MONTGOMERY COUNTY PLANNING DEPARTMENT
THE MARYLAND-NATIONAL CAPITAL PARK AND PLANNING COMMISSION

MEMORANDUM

REVIEW TYPE: **Site Plan Review**
CASE #: **820070260**
PROJECT NAME: **The Rugby Condominium**
APPLYING FOR: Approval of 61 multi-family units including 8 MPDUs, 13.1% of the total units, on 0.47 acres
REVIEW BASIS: Div. 59-D-3 of Montgomery County Zoning Ordinance
ZONE: CBD-1
LOCATION: North Side of Rugby Avenue at the intersection of Auburn and Rugby Avenues, 300 feet east of Norfolk Avenue
MASTER PLAN: 2006 Woodmont Triangle Amendment to the 1994 Sector Plan for the Bethesda CBD
APPLICANT: 4851 Rugby Avenue, LLC
FILING DATE: June 13, 2007
HEARING DATE: April 10, 2008

Public Use and Amenity Space

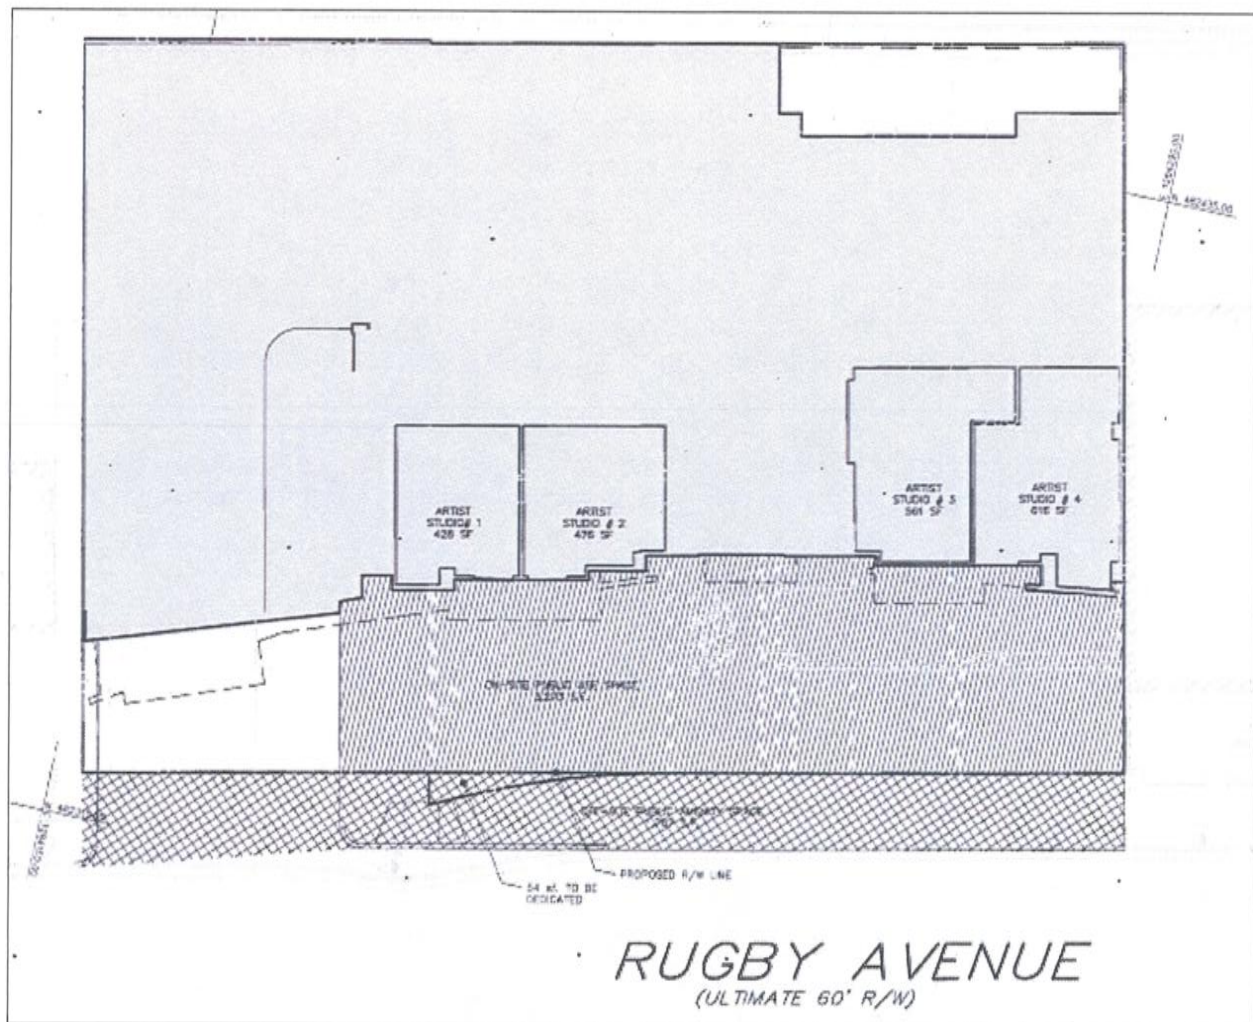
The Applicant proposes to provide on site public use space equivalent to the required 20 percent of the net tract area. This 3,277-square-foot plaza is located in front of the building and provides access to the residents entering the building, the artists renting the studios, and members of the public. In addition to the on-site public use open space, the Applicant is providing streetscape as well as intersection improvements to extend the curb on the south side of Rugby Avenue to provide a safer crosswalk and to bring the sidewalk along the north side of Rugby Avenue into line with the sidewalk to the east of the site. Each of the streetscape improvements will meet the Bethesda Streetscape Standard design.

Artist Studios on the Ground Floor

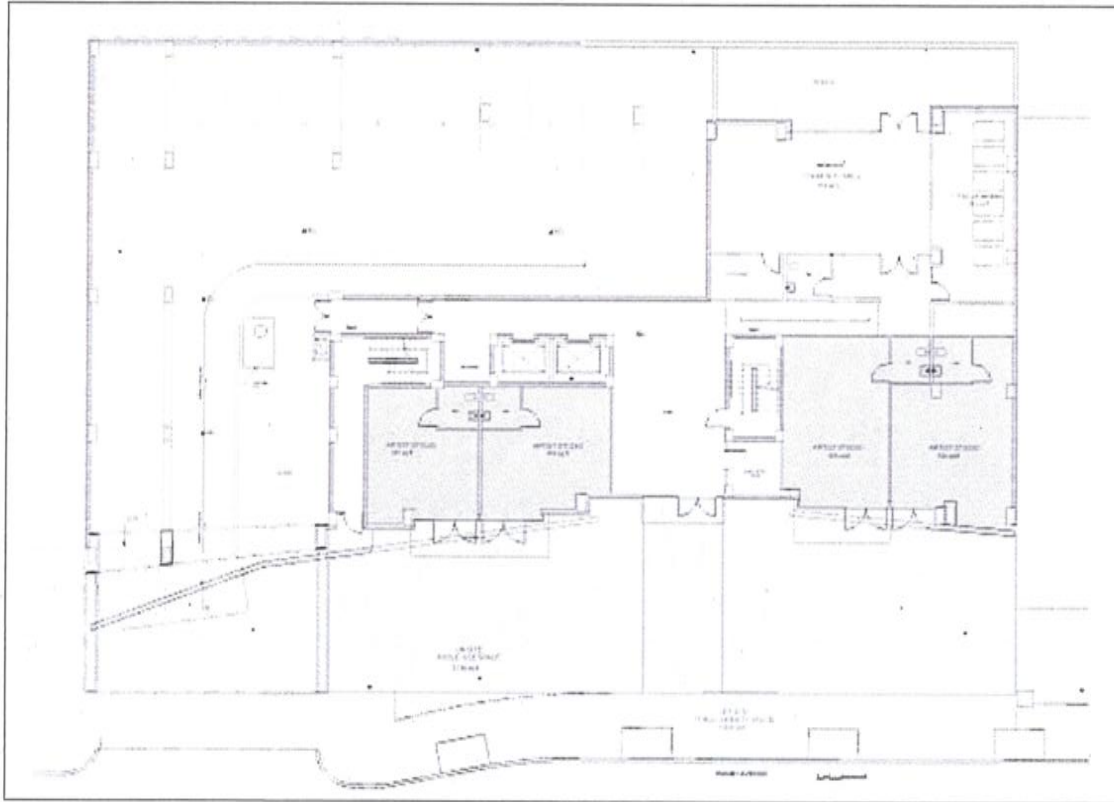
The Applicant is proposing four artist studios, totaling not less than 2,000 square feet, located within the building on the ground floor. Each studio will provide work and exhibition space for community artists. It would be accessible only from the public plaza and will have its own bathroom. The Applicant will enter into a management agreement for these studios with the

Each studio is designed architecturally to open onto the plaza, literally and figuratively, providing ready visual and pedestrian access to the studio spaces. To complement the studios, the public plaza in front of the building is designed to serve as an outdoor exhibition and reception area and could be programmed for smaller community events.
